Re: 3623 Adeline Street, Emeryville

December 4, 1995
File: 10-3002-39/001

**SUBJECT: Letter of Authorization for Conversion of Soil Boring into a 6-inch Extraction Well and Addition of Geoprobe Exploration to Investigation Program
3623 Adeline Street
Emeryville, California**

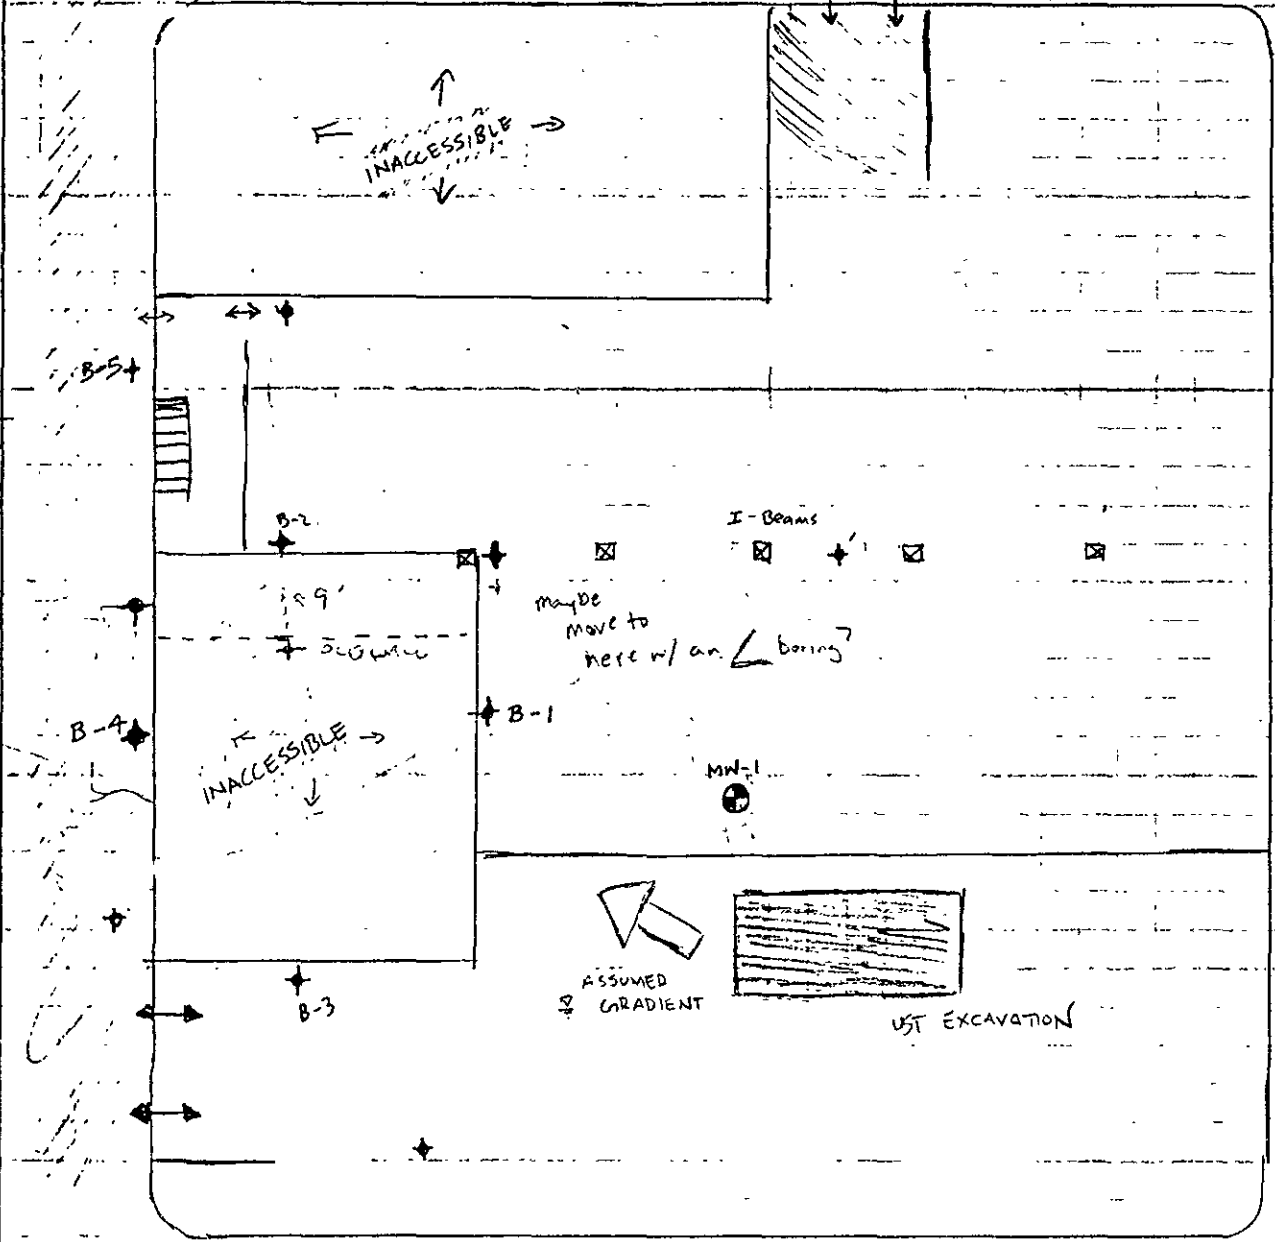
The locations of the 5 geoprobe borings are tentatively located as shown on the map presented in Appendix A. A sixth boring will be located based on the results of the field data collected from B-1 through B-5.
